Lippert In-Wall Slide System

REPLACEMENT OF THE INVERTED GEAR RACK IN-WALL (SCHWINTEK) SLIDE-OUT SYSTEM

TSB Number:	146-001-2022C		
Product:	Inverted Gear Rack In-Wall Slide-Out System manufactured between October 2021 and January 2022		
Date:	August 7, 2024	Labor Rate:	3.4 Hours Allowed (1.7 hours per side)

Identifying the Inverted Gear Rack In-Wall Slide-Out System

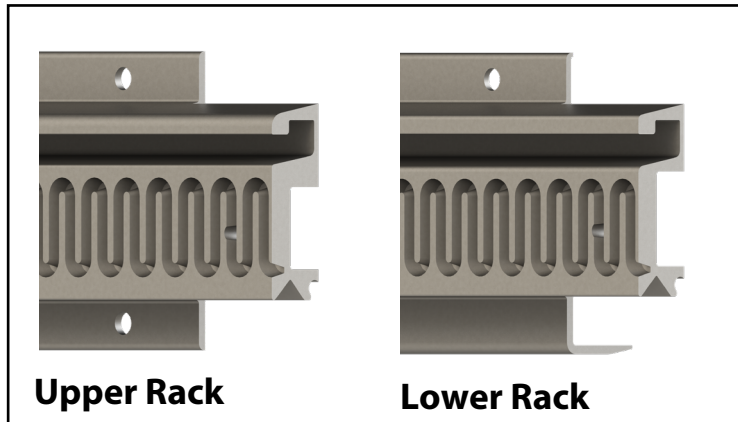
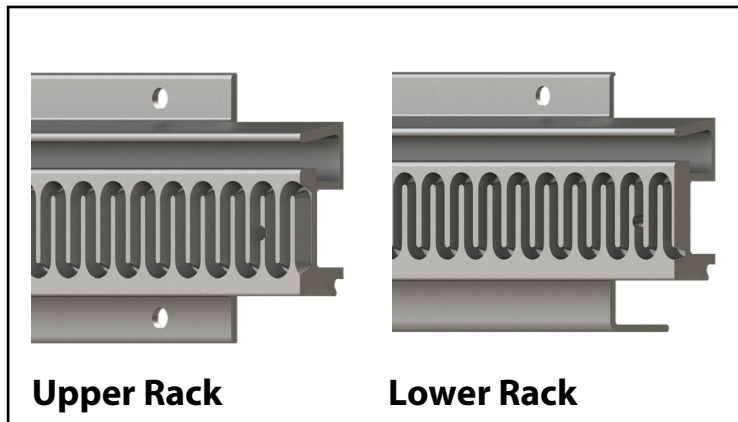
The inspection will be to validate the system as being part of the Inverted Gear Rack In-Wall Slide-Out system. The profile of the gear rack will be as shown below under the subsection "Identifying The Inverted Gear Rack In-Wall Slide-Out System."

Inverted Gear Rack

Standard Gear Rack

If the system has failed and has been verified as the Inverted Gear Rack In-Wall Slide-Out System, the replacement systems are available through Lippert Customer Care Center at (432) 547-7378. Have the Lippert In-Wall System tag handy as this will be needed to identify the correct replacement system.

Kit will include:

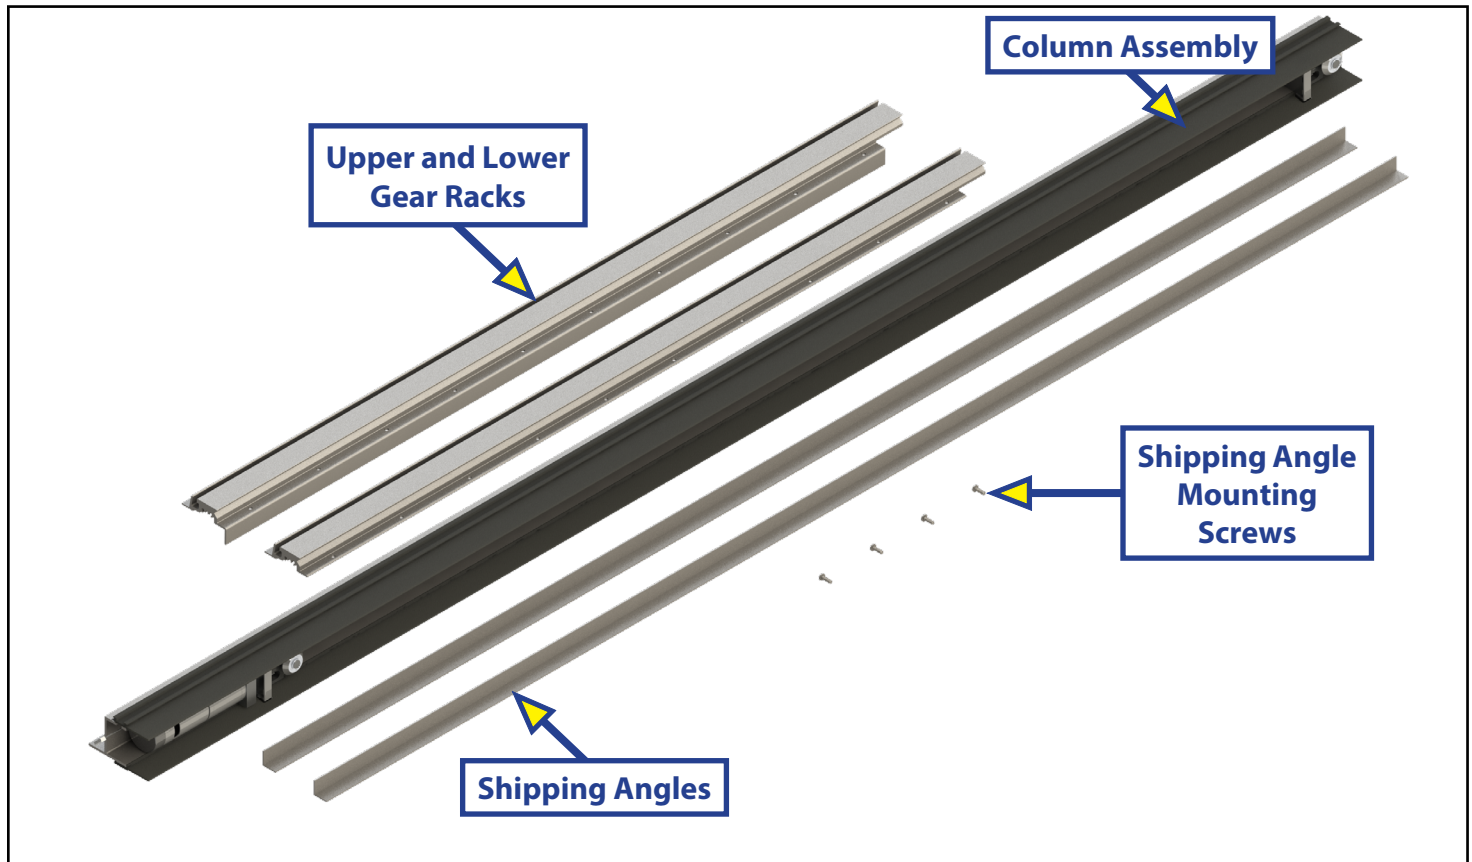
Systems will be shipped partially disassembled in a box or tube.

NOTE: Fixed side shown, kit will include Float side assembly as well.

NOTE: The kit includes replacements for both the fixed and float sides of the system. It is important to replace BOTH sides and use ALL of the components.

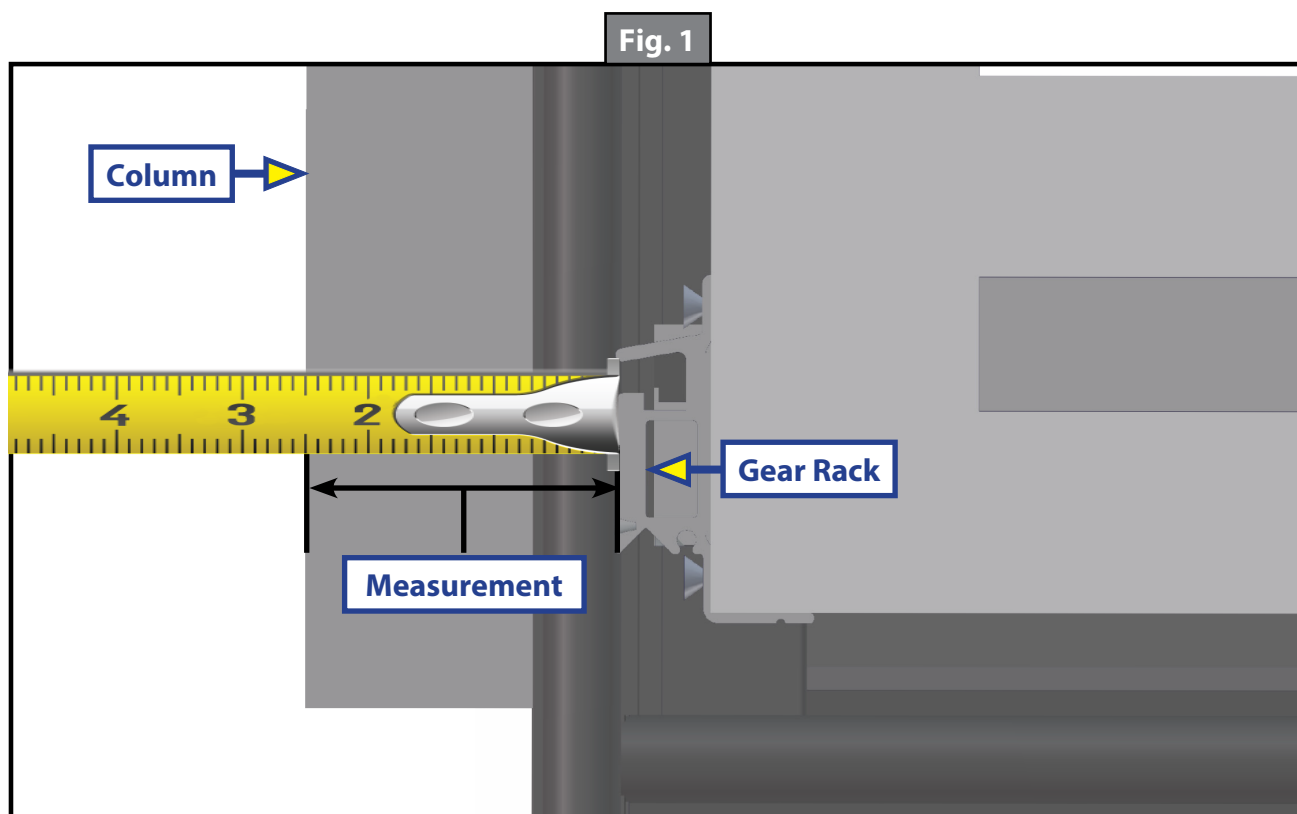
1. Measure from the outside edge of the column to the face of the gear rack at all four gear racks. The standard measurement should be $2\frac{1}{2}"$ plus or minus $\frac{1}{8}"$. Take this measurement when the room is fully extended and again when the room is 3" from fully retracted.

2. Measure the gear racks for parallel. There should be less than $\frac{1}{8}"$ difference between the parallel measurements.
3. Check for proper seal engagement (no binding).
4. Check for damage to gear rack.

The measurement tolerance is $2\frac{1}{2}" \pm \frac{1}{8}"$ for slide-out units.
